Office Action Summary	Application No.	Applicant(s)	
	10/816,559	CHEONG, YEW WEE	
	Examiner	Art Unit	
	Hadi Shakeri	3723

DETAILED ACTION

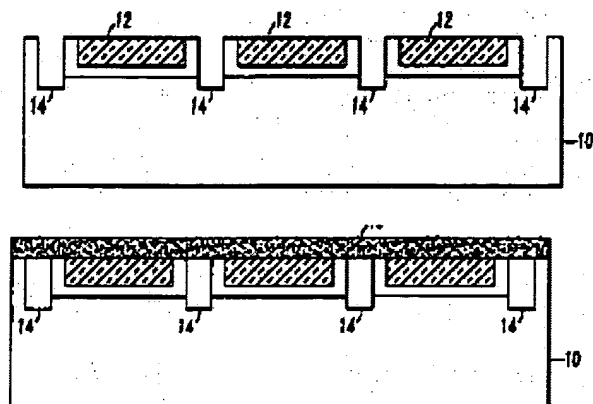
10. Claim 26 recites for a vacuum transfer device to place the workpiece to tape the first side (front side 205), yet, specification and drawings do not disclose nor describe the device, it is unclear what is being claimed, since there is no description, which indicates that the device is not novel and that the device is already used in the art. It is noted that any attempt to describe by limiting and/or defining the device may be considered as introducing new matter, lacking indication for such support in the specification as originally filed.

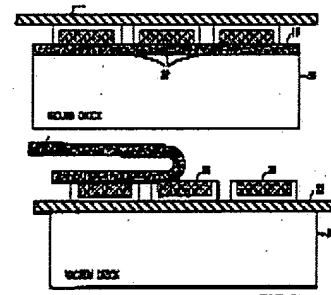
Regarding claims 2, 3, 18 and 19, Riding et al. in view of AAPA as indicated above meets all of the limitations, except for disclosing laser scribing and dicing the wafer, but as indicated by Applicant, e.g., page 6, lines 3-7, it is known in the art for low-K wafer to first laser scribe the wafer and then saw cut it. It would have been obvious to one of ordinary skill in the art, at the time the invention was made, to further modify the above method by laser scribing and saw cutting in view of AAPA to prevent cracking, for wafers having ILD layers.
